CITY OF CODY  
PLANNING, ZONING AND ADJUSTMENT BOARD  
TUESDAY, APRIL 24, 2018  
CITY HALL COUNCIL CHAMBERS @ 12:00 NOON

<b>MEETING DATE:</b>	MARCH 13, 2018	<b>TYPE OF ACTION NEEDED</b>	
<b>AGENDA ITEM:</b>		P&Z BOARD APPROVAL:	X
<b>SUBJECT:</b>	LANDSCAPE AND ARCHITECTURAL REVIEW: HIGH SCHOOL RESTROOM BUILDING EXPANSION AND TICKET BOOTH. SPR 2018-13	RECOMMENDATION TO COUNCIL:	
<b>PREPARED BY:</b>	TODD STOWELL, CITY PLANNER	DISCUSSION ONLY:

<b>MEETING DATE:</b>	APRIL 24, 2018	<b>TYPE OF ACTION NEEDED</b>	
<b>AGENDA ITEM:</b>		P&Z BOARD APPROVAL:	
<b>SUBJECT:</b>	PRELIMINARY AND FINAL PLAT OF THE HIGBIE WEST 40 SUBDIVISION. AN 8-LOT COUNTY SUBDIVISION. SUB 2018-01	RECOMMENDATION TO COUNCIL:	X
<b>PREPARED BY:</b>	TODD STOWELL, CITY PLANNER	DISCUSSION ONLY:

**SOUTH ELEVATION**  
1/4"=1'-0"

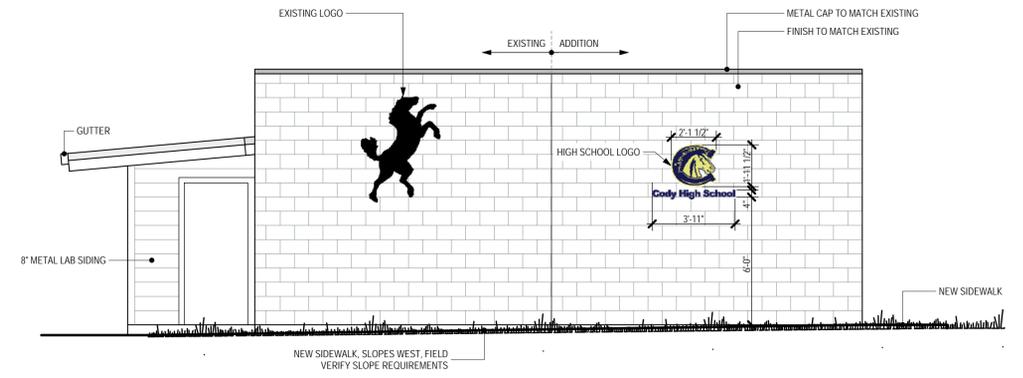
The proposal includes adding a Cody Bronc logo to the south side of the addition. The logo would be approximately 5 square feet in size. Staff's interpretation is that the sign meets the exemption of 10-15-6(A)(17), as it is a school sign on school property, so it is exempt from sign review.

PRELIMINARY PLAT

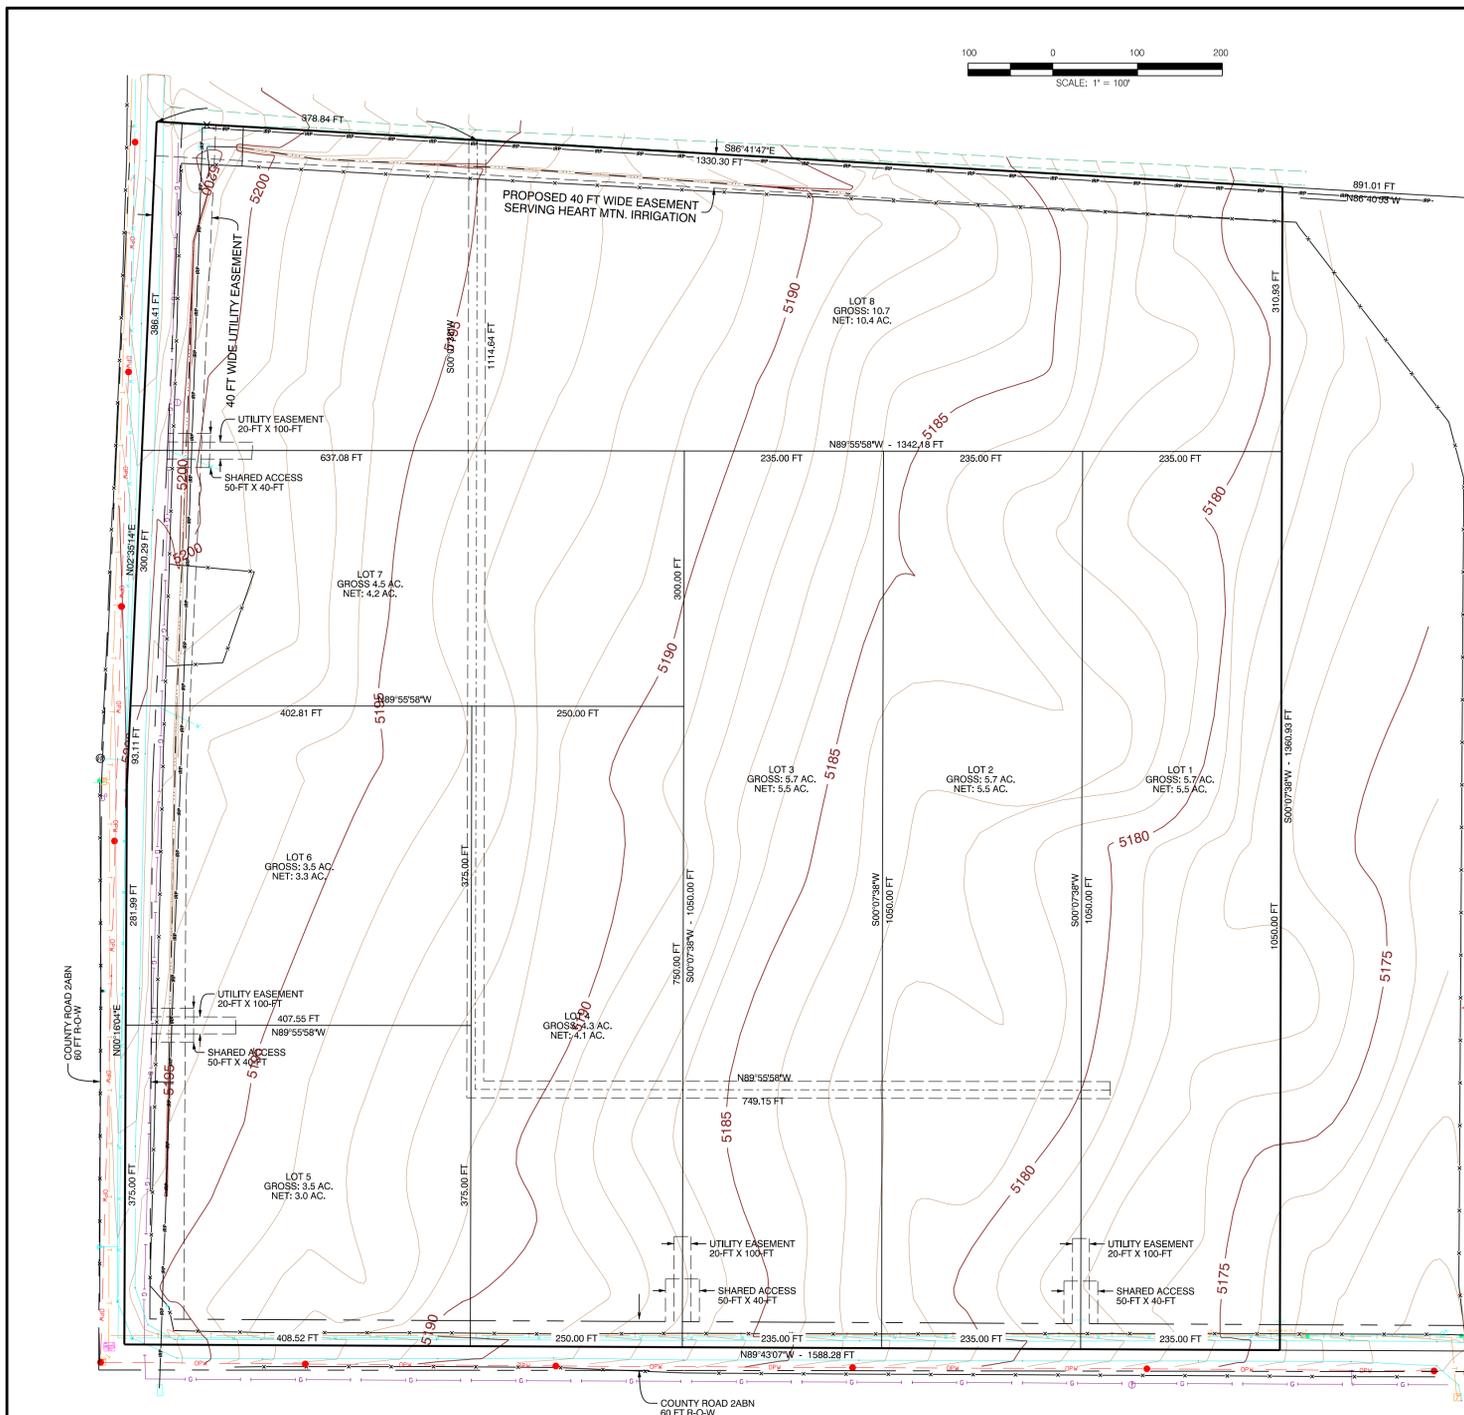
1. The Road 2ABN right of way needs to be clearly labeled on the final plat. (Add road names, right-of-way width, line symbol in legend, and the term "rights-of-way" to the certificate of dedication.

2. The application shows the electric transformers being set near the common lot lines just beyond the shared access driveways. It is recommended that the utility easement be widened to 30 or more feet and the transformer be placed to one side. This configuration would allow the property owners to continue the shared driveways without having the transformer in the way. It would also be out of the way of any future road extension.

3. Note 5 appears irrelevant, as domestic water is being utilized for domestic use and Heart Mountain Canal water for irrigation.
4. The requirement in the subdivision code relating to an agreement to annex has been discussed in the last few County subdivisions. Council has waived the requirement in those situations and is recommended to do so again here.

5. The County has required that the property not be further divided in the future. To avoid potential future confusion, the note should include language to the effect of "...until such time as located within the city limits and provided with City utility services."

1. Label the 2ABN right-of-way as noted in the staff report (Other, #1).
2. Modify/remove Note 5 as needed.
3. Clarify the "no further subdivision" note, as noted in the staff report (Other, #5).

The applicant is authorized to modify the utility easement/shared access configuration to address the transformer location recommendation, if desired.
